PRE-BID ADDENDUM #03

DATE 2026-01-20

PROJECT NAME Ferndale Martin Road Park Service Building

PROJECT NUMBER 2024008

Title
**ARCHITECTURAL
SITE PLAN**

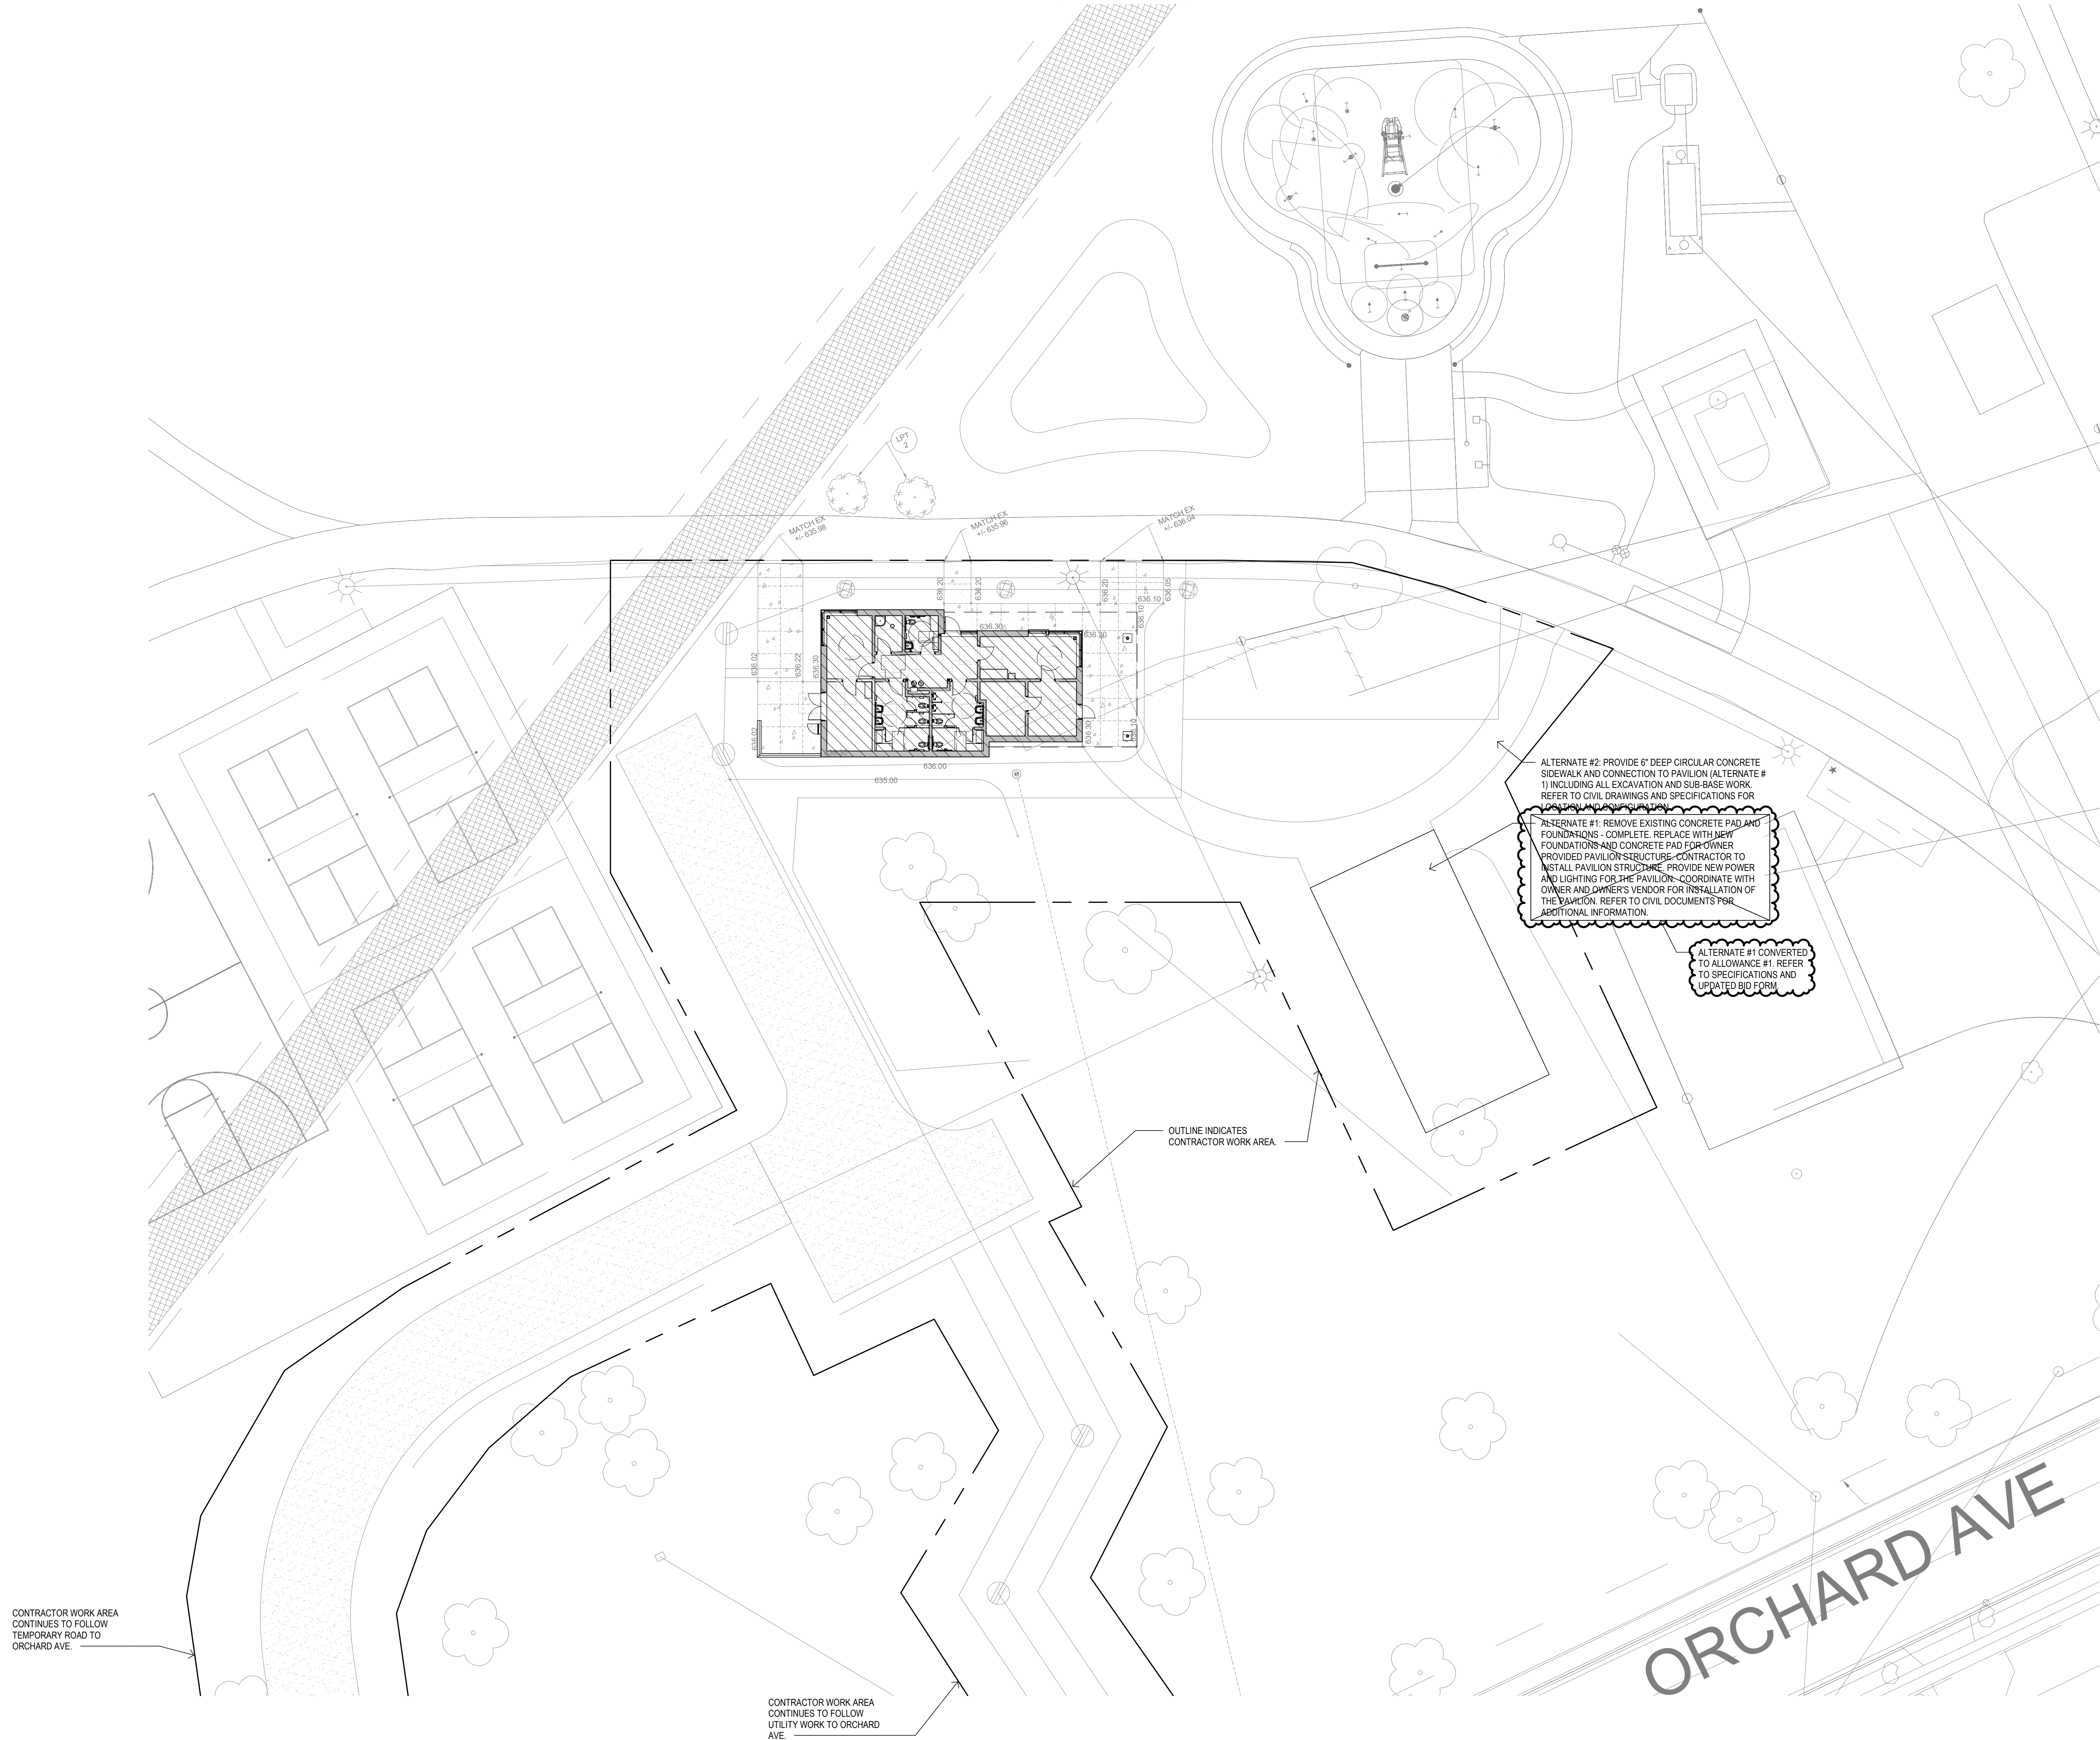
Refer to Sheet(s) AS101

- A. Updated to convert Alternate #1 to Allowance #1. Refer to Specifications for additional information.
